## Annexure B - NZ Transport Agency Designation Council Submission Table Updated 11/02/2016

## Annexure C – NZ Transport Agency Designation Council Correction Table

Annexure D – NZ Transport Agency Mapping Corrections Updated 11/02/2016

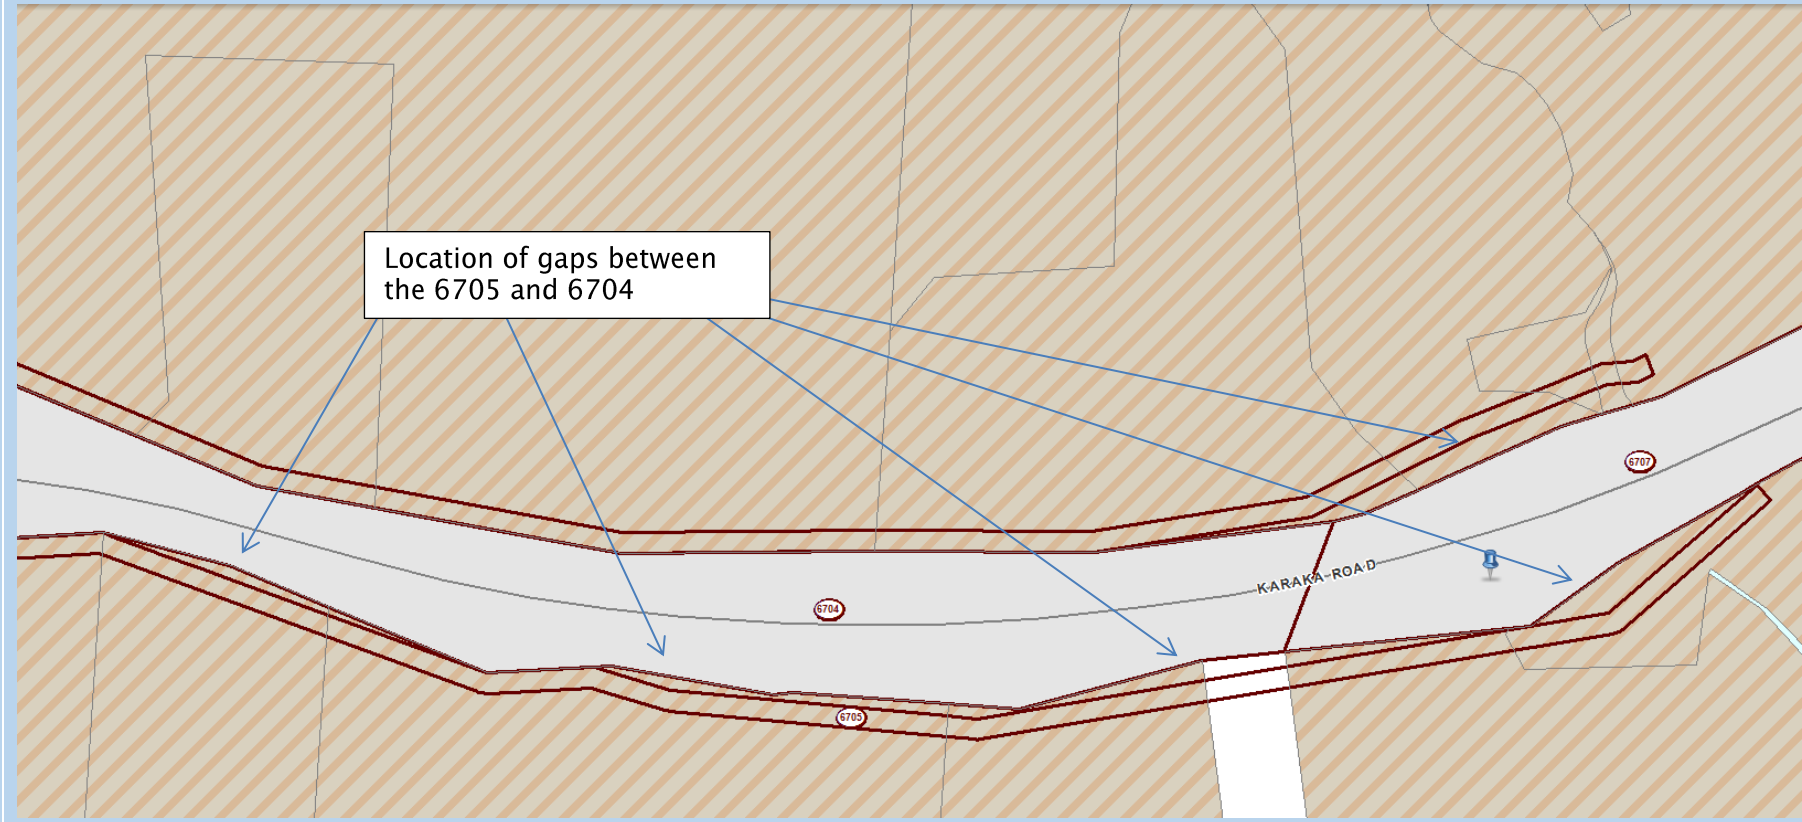
6704  
1725- 438 Mapping Correction  
 Amend the 6704 designation boundary at the intersection of State Highway 22 and Glenbrook Road to reflect the amendment made in 2010 (LU 10105) for a proposed roundabout (by adding the hatched areas). Council has agreed with this correction with a similar submission point (5716-2709).

1725- 438 Mapping Correction  
 The State highway 22 designation (6704) boundary is incorrect and should follow the current boundary with the road widening designation (6705) removing the identified gaps between the two designations. Council has agreed with this correction with a similar submission point (5716-2708).

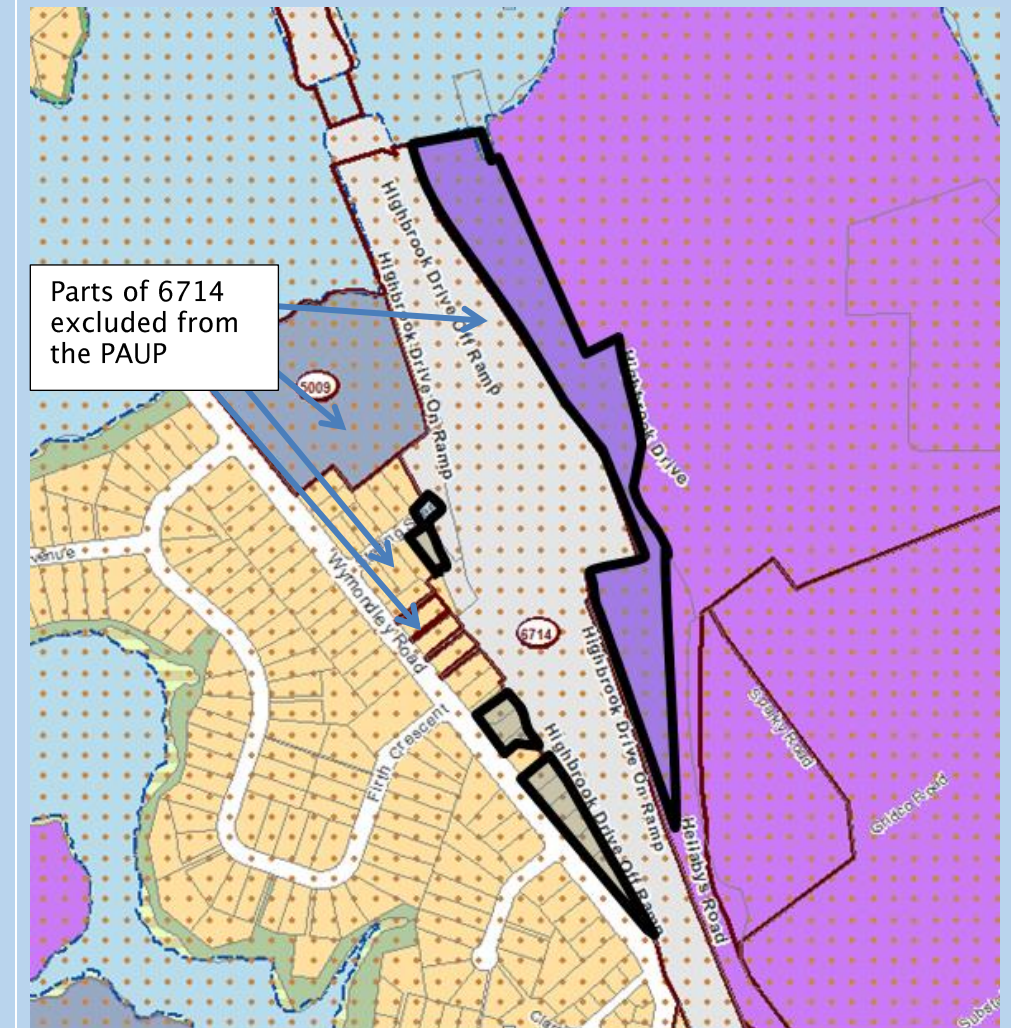
**1725-395 Mapping Correction**  
Submitted to amend 6714 to include missing sections of designation surrounding the Highbrook Road Interchange (see areas detailed on the adjacent PAUP map). These identified areas have not been rolled back and designations full extent should be correctly displayed on the PAUP maps.

The Agency has discussed this submission point with Council planners. While the Council does not consider that it is appropriate at this stage in the process for the Council to comment on changes to a designation stemming from submissions it has not made, the Council accepts that should the Panel recommend changes to the designation boundaries in accordance with the Agency's submission, it will be necessary as a consequential amendment to apply the Strategic Transport Corridor Zone over the land to which the amended designation applies.

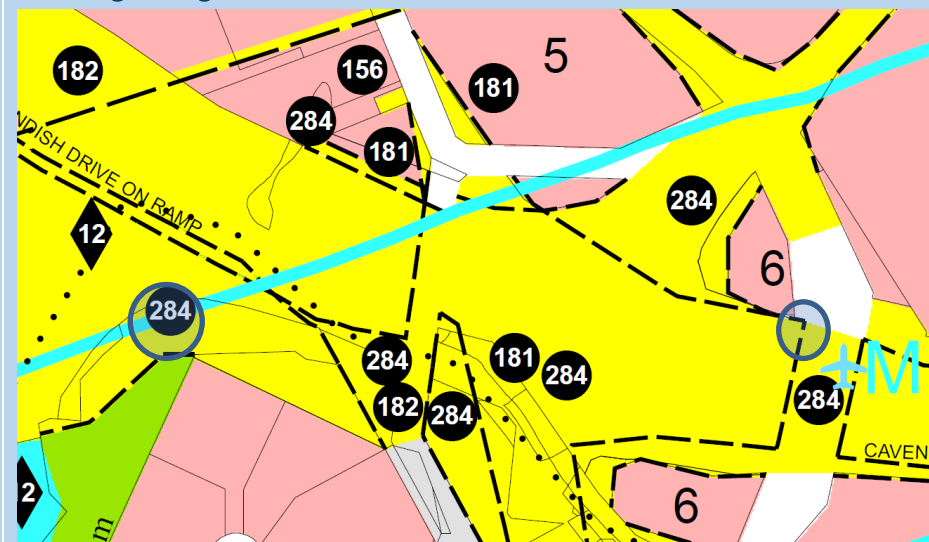
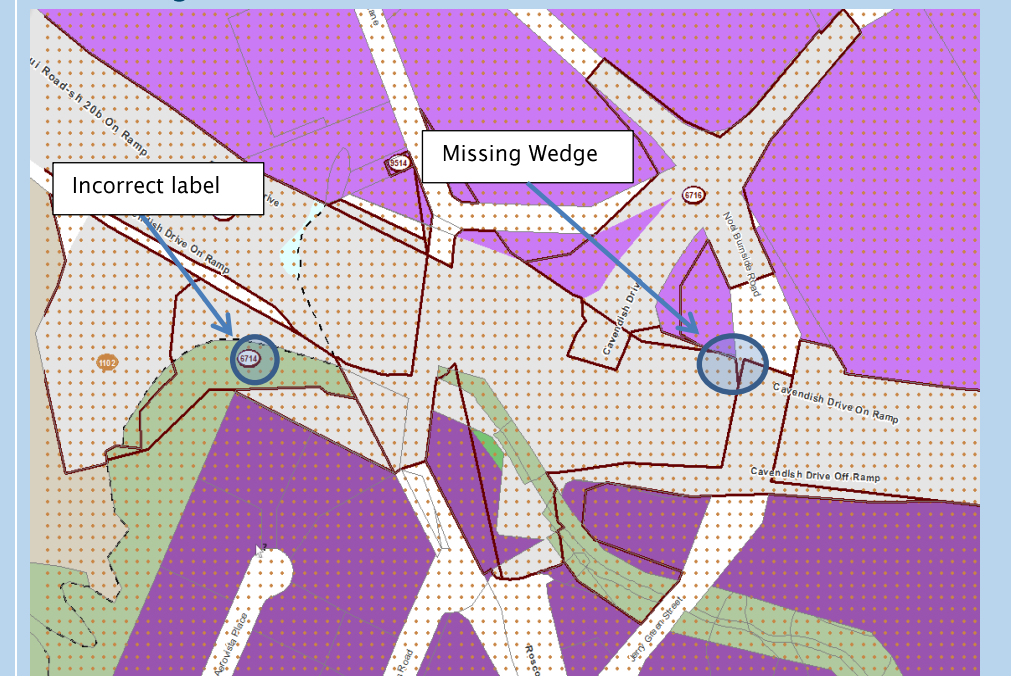
**1725-439 Mapping Correction**  
Include in 6716 the small missing wedge on the Cavendish drive onramp (See circled area on adjacent map). Also the label for a section of designation on the eastern side of the interchange requires correction. Under the operative plan this area is designated 284 which corresponds to 6716 and should be labelled appropriately.  
Council has agreed with both corrections points with similar submission points (5716-2716 & 2715).

1725-397 Mapping Correction

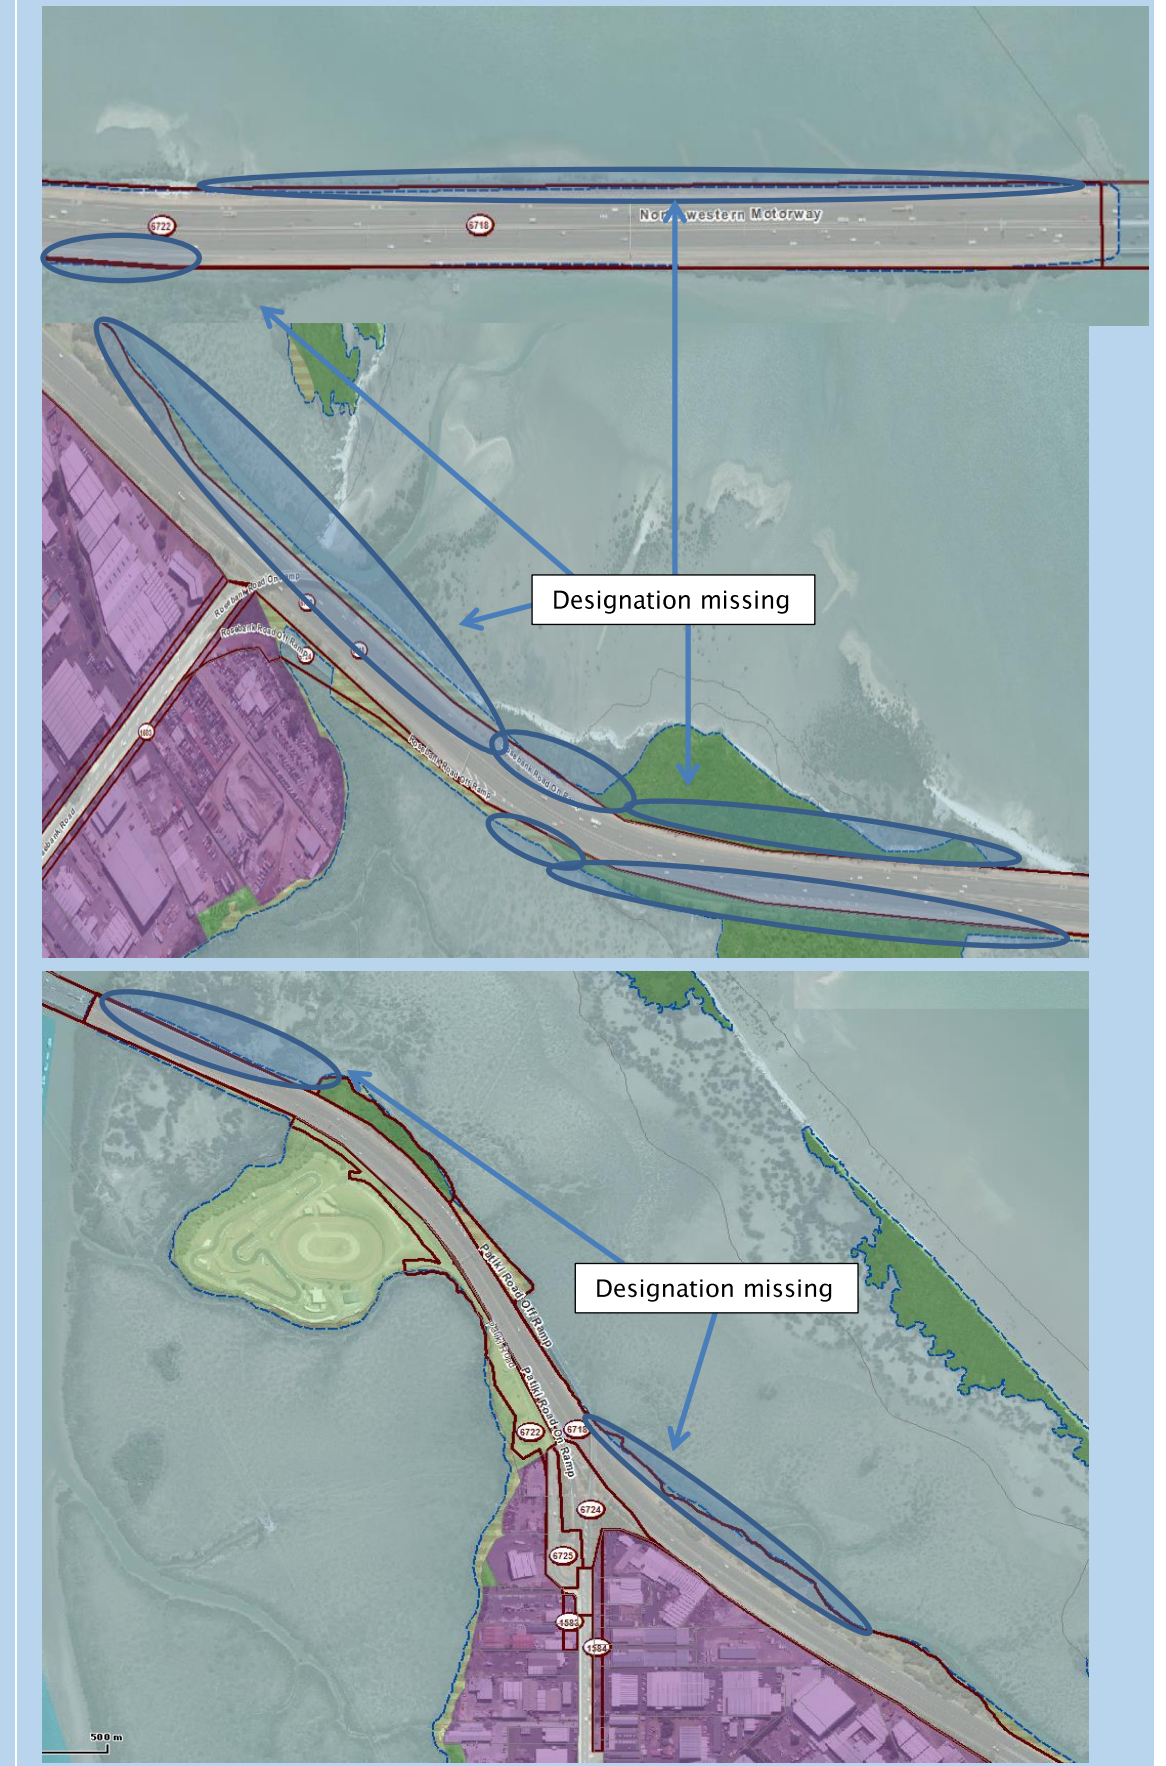
Both 6718 & 6722 cover a wider extent than that illustrated in the PAUP between the State Highway 16 causeway and Whau bridge. These designations require correction to align with the current Operative Plan.

The Agency has discussed this submission point with Council planners. While the Council does not consider that it is appropriate at this stage in the process for the Council to comment on changes to a designation stemming from submissions it has not made, the Council accepts that should the Panel recommend changes to the designation boundaries in accordance with the Agency's submission, it will be necessary as a consequential amendment to apply the Strategic Transport Corridor Zone over the land to which the amended designation applies.

1725-399 Mapping Correction

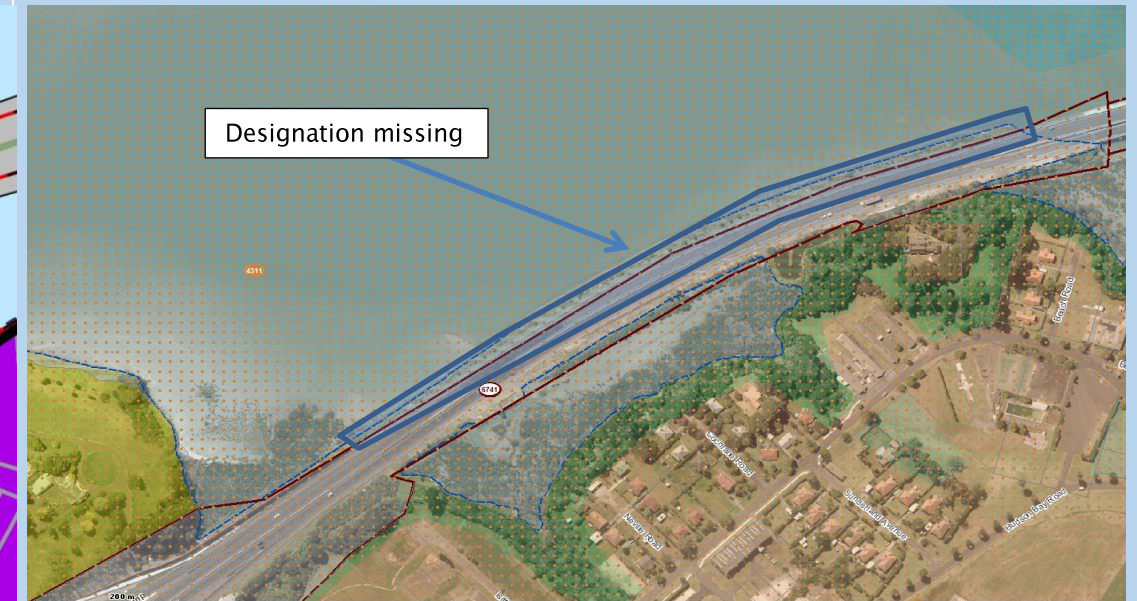
Part of the Agency's 6741 designation has been replaced with the Coastal Transition Zone. The designation (as set out in the Operative Plan) covers a wider extent than that illustrated in the PAUP and requires correction.

The Agency has discussed this submission point with Council planners. While the Council does not consider that it is appropriate at this stage in the process for the Council to comment on changes to a designation stemming from submissions it has not made, the Council accepts that should the Panel recommend changes to the designation boundaries in accordance with the Agency's submission, it will be necessary as a consequential amendment to apply the Strategic Transport Corridor Zone over the land to which the amended designation applies.

1725- 400 Mapping Correction

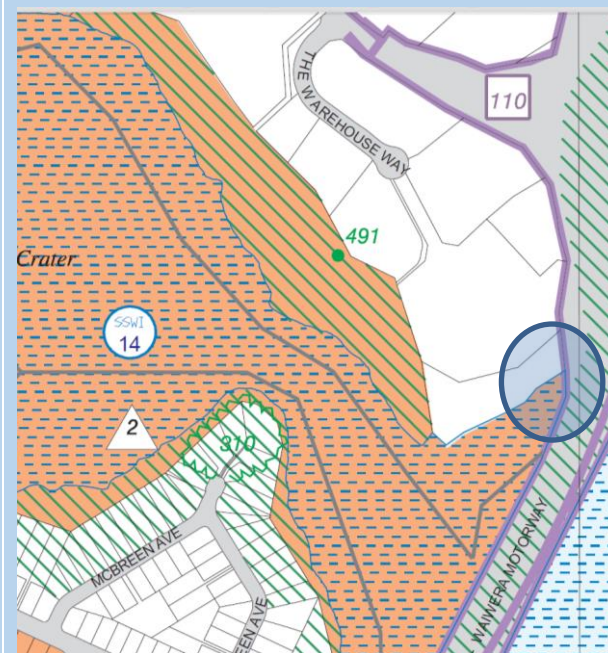
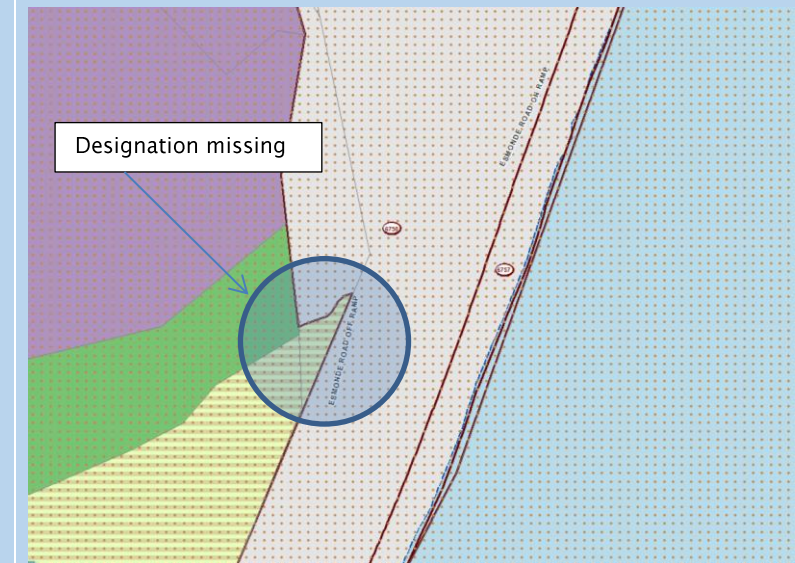
Part of the Agency's designation has been replaced with the Coastal Transition Zone. The aerial photography layer clearly shows the land area is above the MHWS and is occupied by the Esmonde Road Off Ramp and ancillary areas.

The Agency has discussed this submission point with Council planners. While the Council does not consider that it is appropriate at this stage in the process for the Council to comment on changes to a designation stemming from submissions it has not made, the Council accepts that should the Panel recommend changes to the designation boundaries in accordance with the Agency's submission, it will be necessary as a consequential amendment to apply the Strategic Transport Corridor Zone over the land to which the amended designation applies.
